Arup - Fire Consultant

Cambridge Civic Quarter

RIBA Stage 2 Fire Strategy Report - Guildhall

Drawing Title
Proposed Second Floor Plan

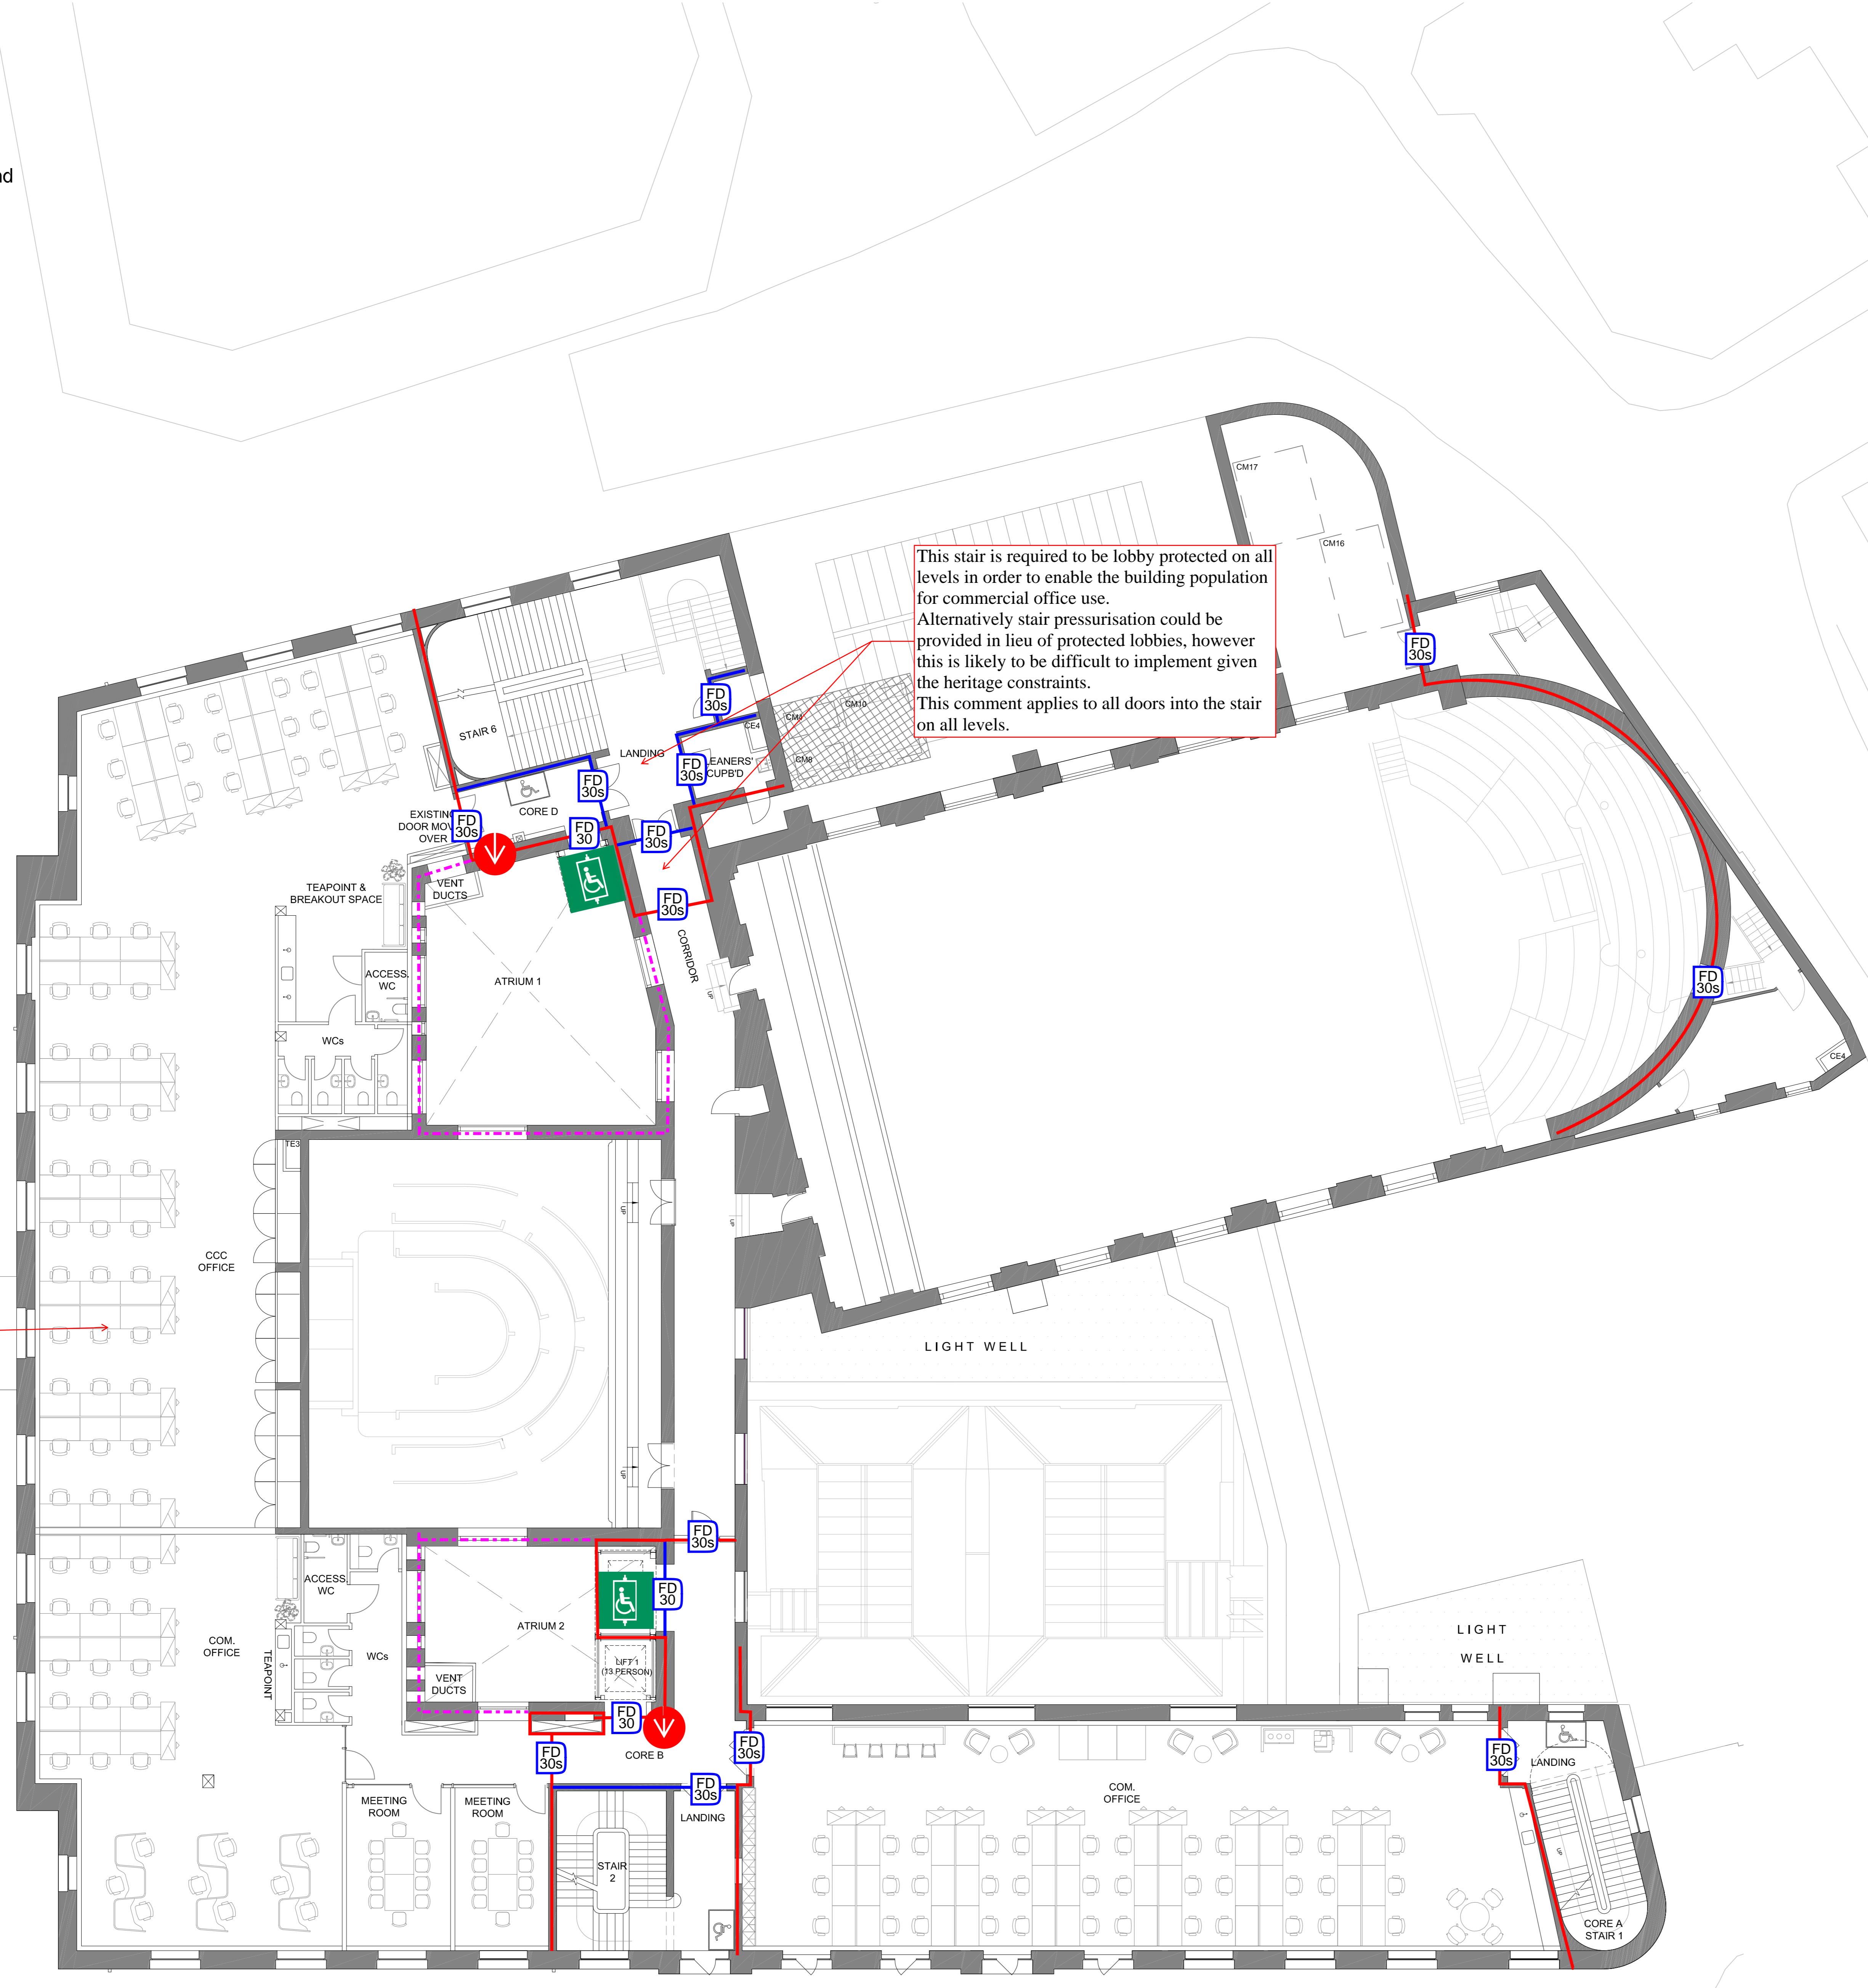
This stair is required to be lobby protected on all levels in order to enable the building population for commercial office use. Alternatively stair pressurisation could be provided in lieu of protected lobbies, however this is likely to be difficult to implement given the heritage constraints. This comment applies to all doors into the stair on all levels.

Office on upper levels
It is assumed that each office space on the North elevation forms a single lease space. If the desire is to split these, the means of escape will need to be required as separate occupancies cannot pass through an adjacent occupancy to escape. Where this is required to reach a stair, this should be via a protected corridor. This will cause a decrease to the amount of lease space on each level if added.

Drawing Title
Proposed Third Floor Plan

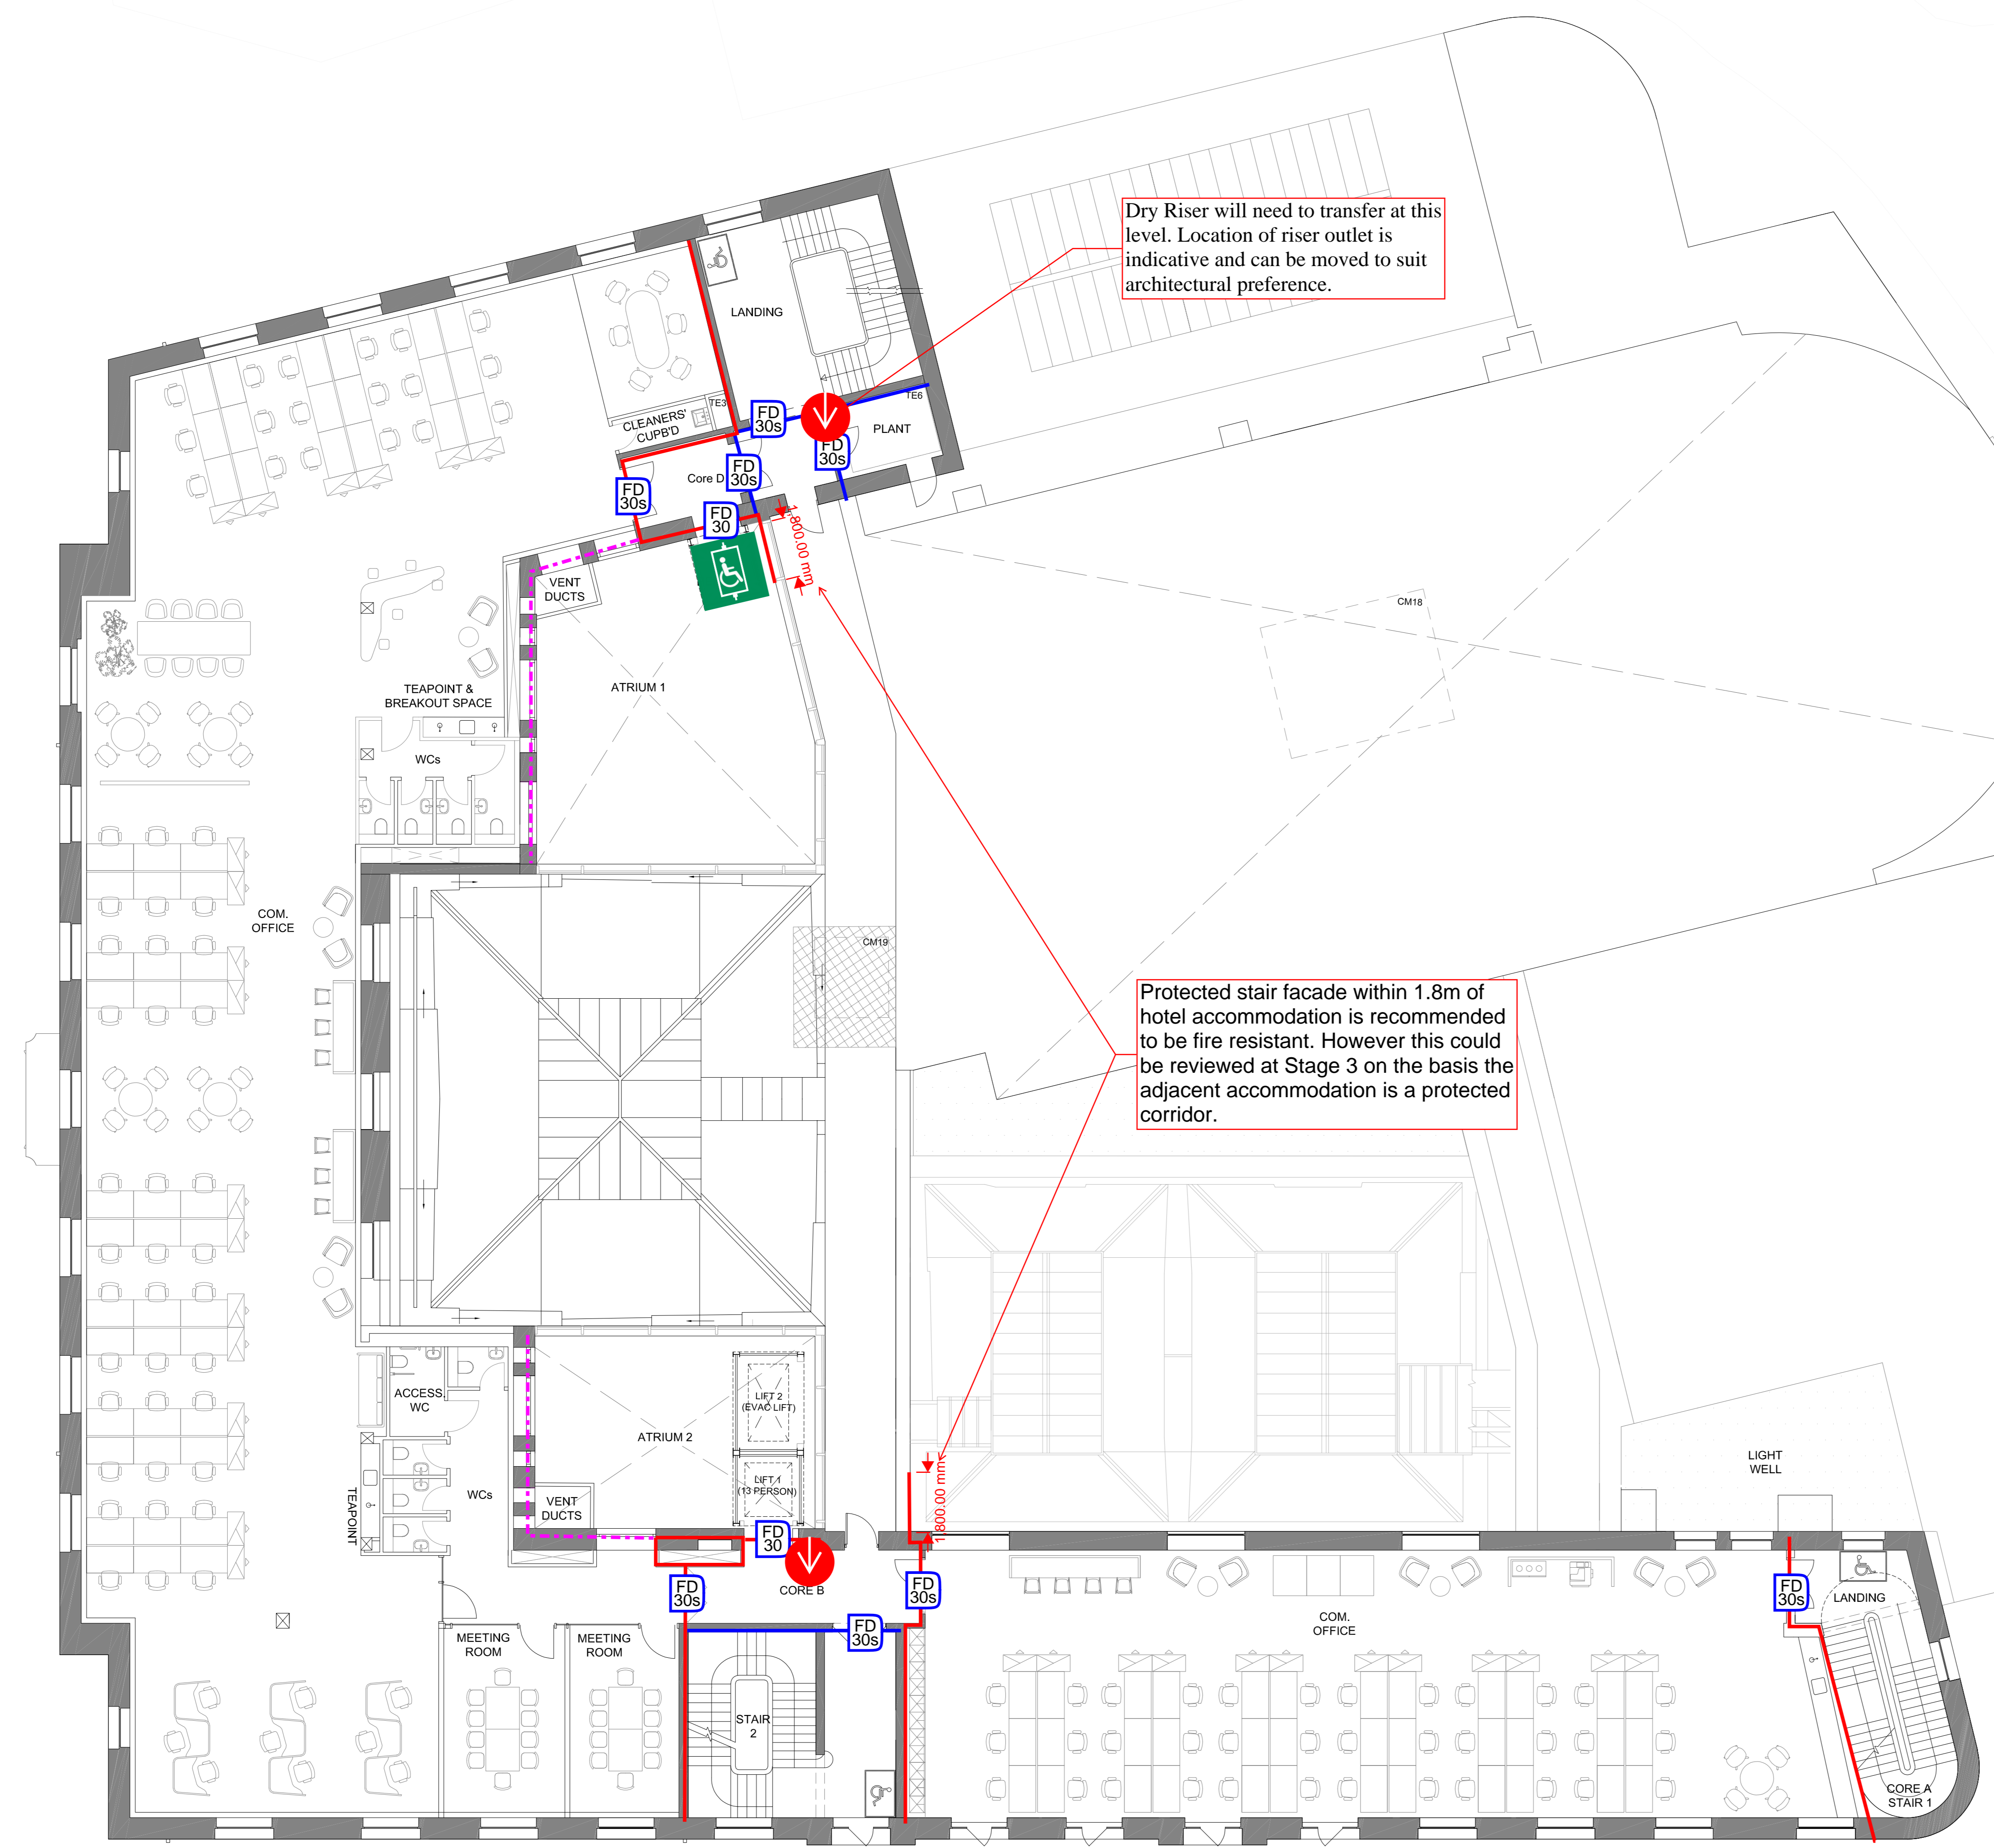
Dry Riser will need to transfer at this level. Location of riser outlet is indicative and can be moved to suit architectural preference.
